ES_LPC43S50/S30/S20

Errata sheet LPC43S50, LPC43S30, LPC43S20

Rev. 1.8 — 20 September 2019

Errata sheet

3.9 ISP.2

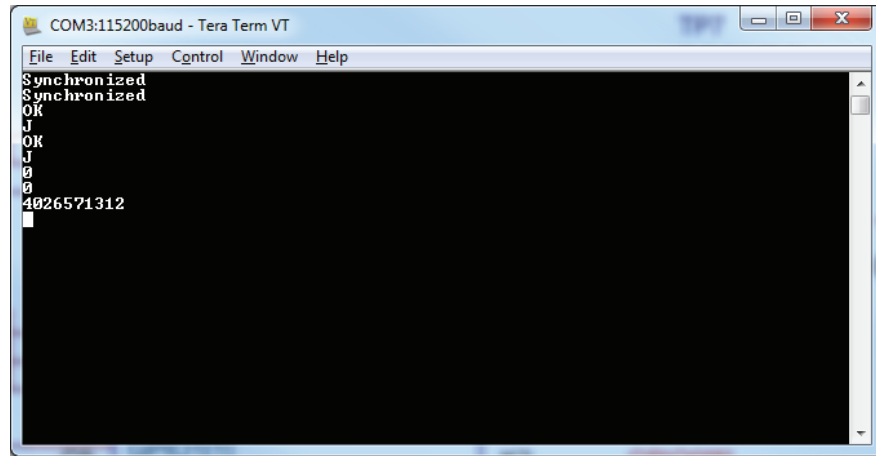
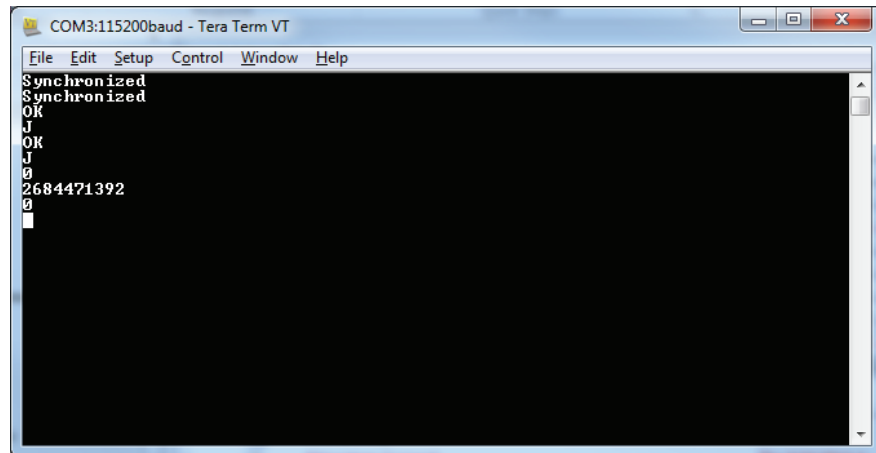
The 'J' command in ISP mode should return an error code, followed by an ASCII string representation of the part ID, followed by a 0. However what is actually returned is the error code, followed by a 0, followed by an ASCII string representation of the part ID. The problem is the last two items returned are swapped.

There is no work-around for this problem.

3.12 OTP.2

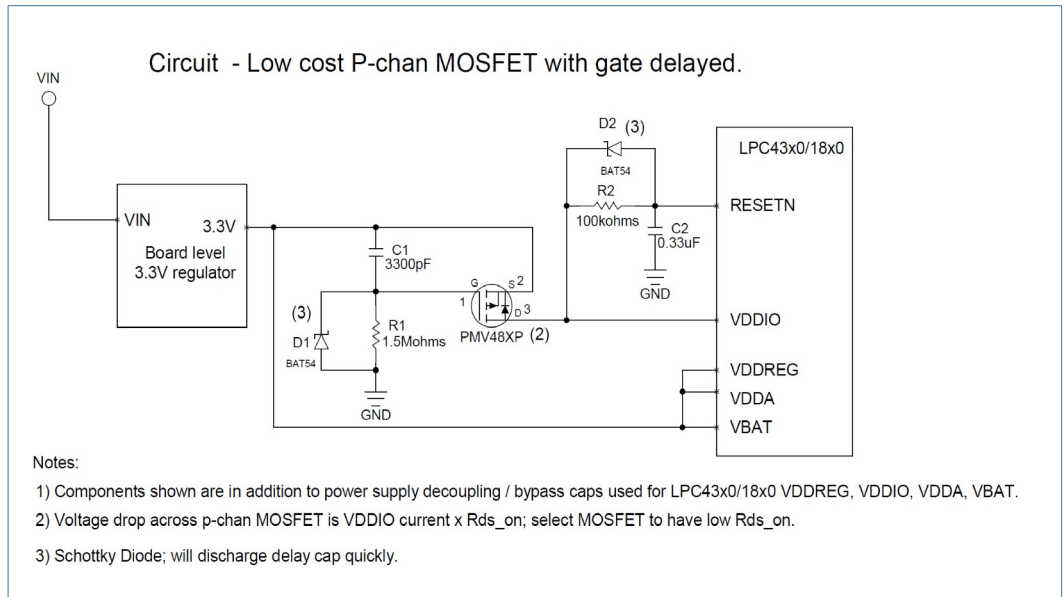
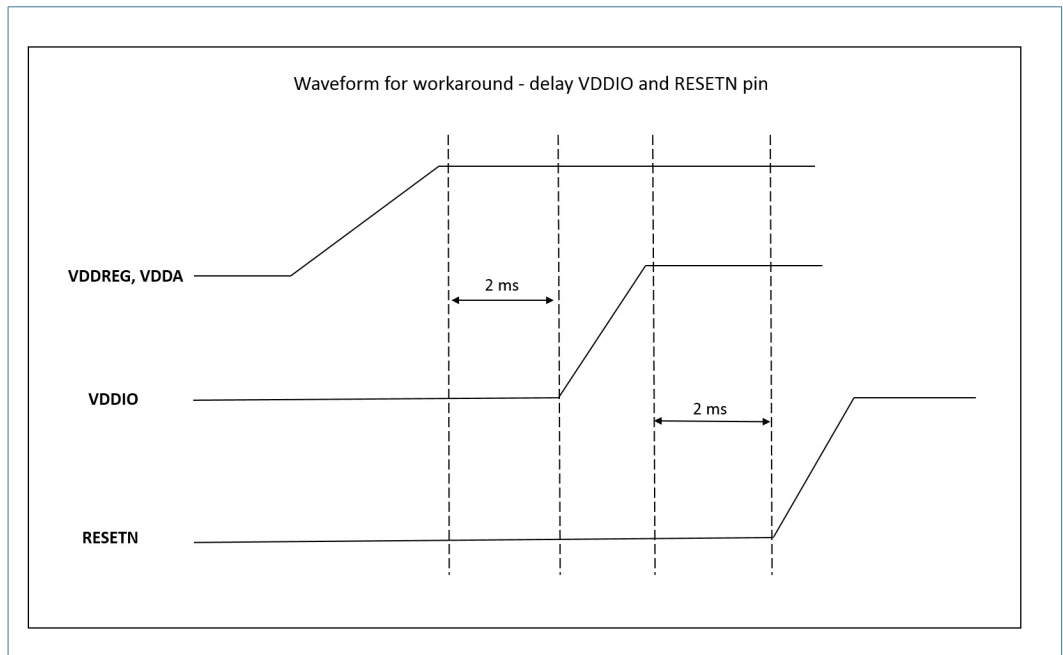
On all packages, repeated power cycling of the device may cause erroneous programming of the OTP banks. During ramp-up, the VDDREG supply voltage does not have enough time to settle and initialize the OTP controller before valid programming voltage is reached on the VPP pin. This may cause accidental programming of the OTP banks. Accidental programming of the OTP banks does not occur during Power-down of the supply voltage.

- Do not tie VDDIO to VDDREG and VDDA pins. The power supplied to the VDDIO pin should be delayed by 2 ms after the power supply on the VDDREG and VDDA pins stabilizes at the operating voltage level. The signal to the RESETN pin must also be delayed by 2 ms after the power supply on the VDDIO pin stabilizes at the operating voltage level.

The following circuit diagram is an example that shows the P-channel MOSFET with the gate delayed and the R-C delay circuit connected to the RESETN pin.

The following diagram shows the waveform for the work-around.

Fig 3. PMC wake-up keep-out area

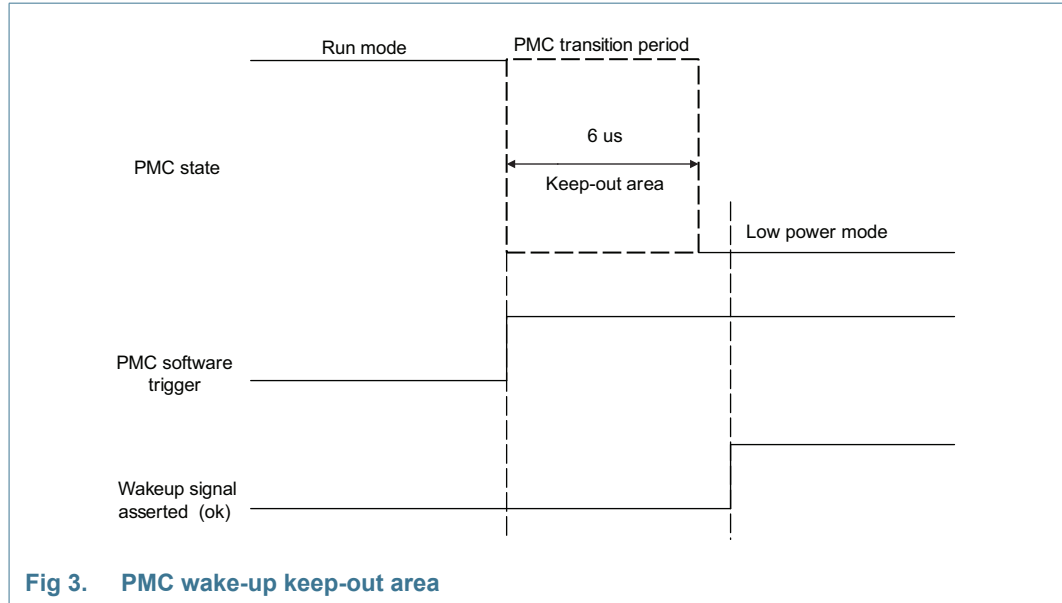
When the chip is in a transition from active to Deep Sleep, Power Down, or Deep Power Down, wake-up events are not captured and they will block further wake-up events from propagating. The time window for this transition is 6 μ s and is not affected by the chip clock speed. After a wake-up event is received during the PMC transition, the chip can only recover by using an external hardware reset or by cycling power.

Make sure that a wake-up signal is not received during the Deep Sleep, Power Down, or Deep Power Down transition period. An example circuit to work around this could include an external 6 μ s one shot which could be triggered via software using a GPIO line when entering Deep Sleep, Power Down, or Deep Power Down mode. The one-shot's output could be used to gate the wake-up signal(s) to prevent receiving a wake-up signal during the PMC transition period. Depending on the system design, it may also be needed to latch the wake-up signal(s) so that they will still be present after the one-shot's 6 μ s time-out.

Fig 4. Suggested USB0 to low-speed peripheral connections

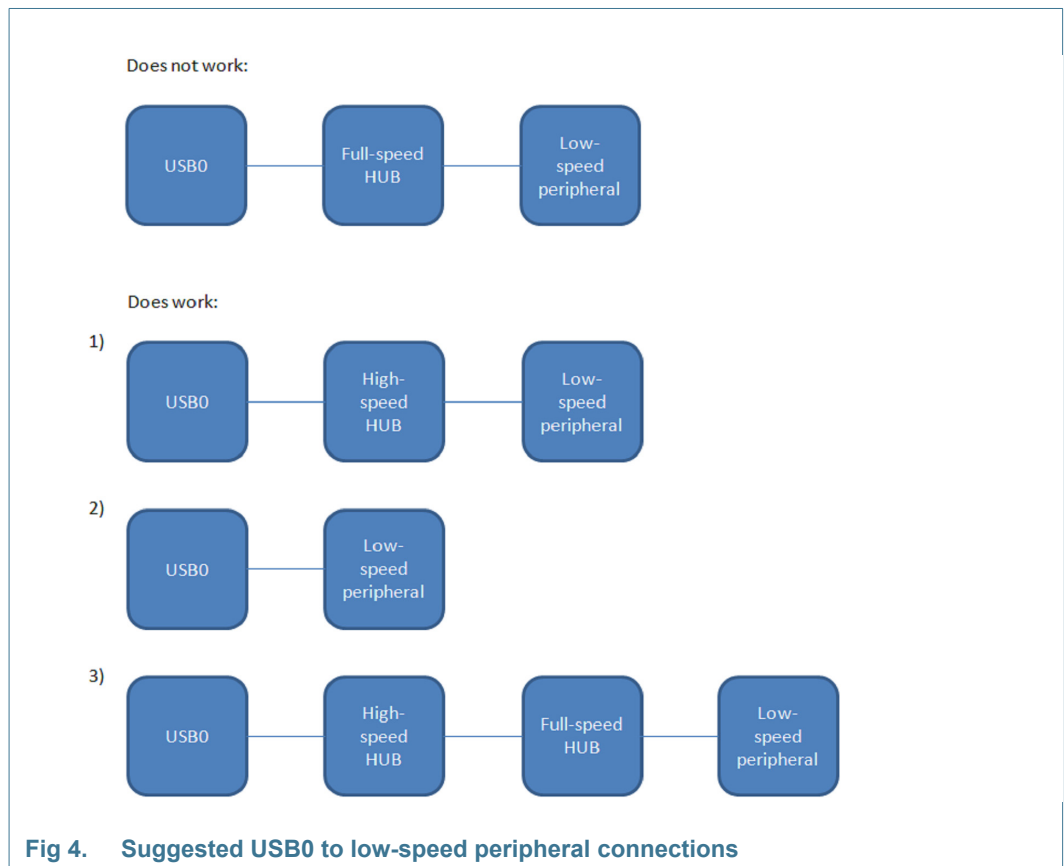
The USB controller called USB0 is unable to communicate with a low-speed USB peripheral in host mode when there is a full-speed hub directly connected to the USB0 port and a low-speed peripheral is connected in the tree somewhere below this full-speed hub. Only USB0 has this problem; the other USB controller, USB1 does not.

There is no work-around for this problem. It is suggested that the low-speed USB peripheral is either connected directly to USB0 or a high-speed hub is placed between that peripheral and USB0.
